**SERVICE INFORMATION BULLETIN**

**NUMBER:** 15-271-20  
**DATE:** 08/31/20

**SUBJECT:** Discontinuation of “Stitcher” App and News Radio Feature from STARLINK App: Gen 2.0, 2.1, (Fujitsu / Denso TEN ) and Gen 3.0, 3.1 (Harman) Audio Systems

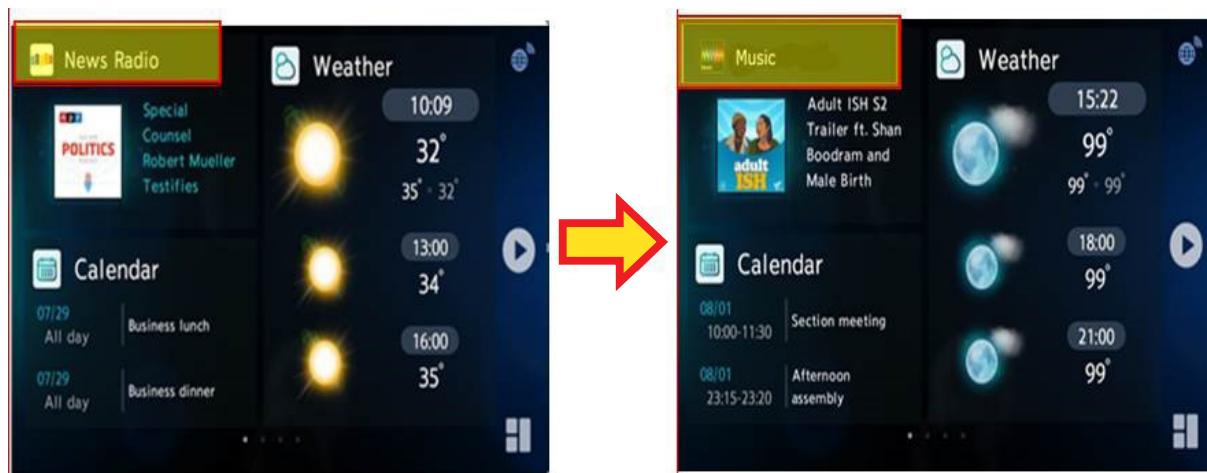
This Service Information Bulletin announces discontinuation of both the “Stitcher” app and the related News Radio feature from the STARLINK app lineup effective 12:00 midnight on Thursday, September 24, 2020. This change effects Denso TEN (a.k.a. Fujitsu TEN) Generation 2.0 and 2.1 along with Harman Generation 3.0 and 3.1 infotainment / audio systems. Users will likely receive notification on their display as shown below.
